Swift Current Research and Development Centre  
CONTRACT NO. 23 – Phytotron Exhaust Modifications  
CONTRACT #465-1-16-C44

Addendum No. 3

Drawing #ME01 Rev 1 dated 09/17/2020

2 PGW 36 AND PGW 40 GROWTH CHAMBER CONNECTION DETAIL  
N.T.S.

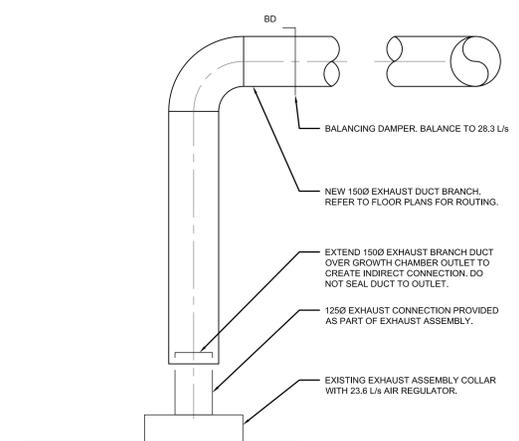
- a) Reference: Drawing 1/ME01
- Revise model numbers for GC-16 and GC-17 from PGW40 to PGW36.
- b) Reference: Detail 2/ME01
- Revise detail title to “PGW 36 AND PGW 40 GROWTH CHAMBER CONNECTION DETAIL”
  - Revise note regarding growth chamber collars to read  
“EXISTING PGW 36 AND PGW 40 GROWTH CHAMBERS

CONTRACTOR IS TO INCLUDE FOR CONVIRON TO PROVIDE INSPECTION SERVICES. EXHAUST ASSEMBLIES ARE INSTALLED AS PER MANUFACTURERS INSTRUCTIONS. CORRECT ANY DEFICIENCIES IDENTIFIED BY CONVIRON DURING THESE INSPECTIONS AT NO ADDITIONAL COST.

AT THE CONTRACTORS OPTION, LABOUR FOR THE INSTALLATION OF EXHAUST CONNECTIONS CAN BE PROVIDED BY CONVIRON.

ALL EXISTING GROWTH CHAMBER EXHAUST PORTS ARE TO BE SEALED AS PER MANUFACTURERS INSTRUCTIONS

TYPICAL OF 12 GROWTH CHAMBERS.”

3 ATC 40 AND PGC FLEX GROWTH CHAMBER CONNECTION DETAIL  
N.T.S.

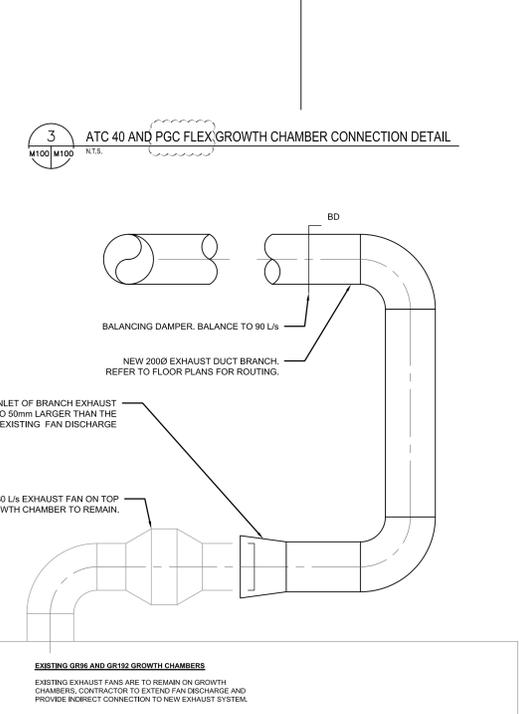
- c) Reference: Detail 3/ME01

- Revise detail title to “ATC 40 AND PGC FLEX GROWTH CHAMBER CONNECTION DETAIL”
- Revise note regarding growth chamber to read  
“EXISTING ATC 40, PGC FLEX GROWTH CHAMBERS

EXHAUST COLLARS ARE EXISTING ON THESE GROWTH CHAMBERS.”
